Seismic Evaluation Guidance

*Screening, Prioritization and
Implementation Details (SPID) for the
Resolution of Fukushima Near-Term Task
Force Recommendation 2.1: Seismic*

Draft Report, September 2012

Figure 3-2
Example Comparison of GMRS to SSE and LHT (5% Damping)

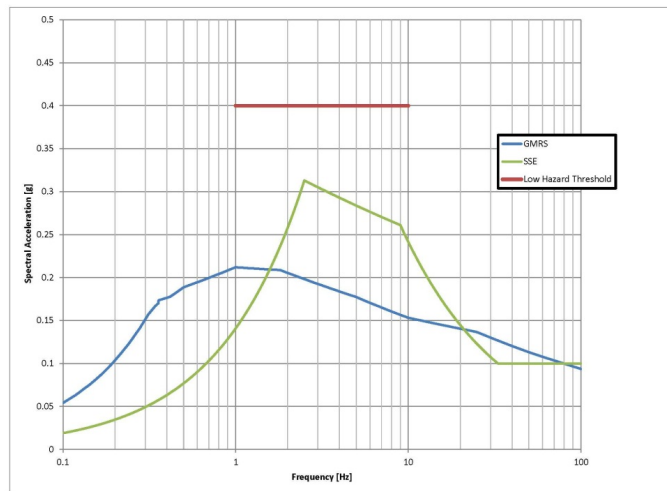
Comment [C7]: Example in Figure 3-2 would need to perform high frequency confirmation.

Comment [C9]: GMRS also needs to be below LHT. Just to be clear.
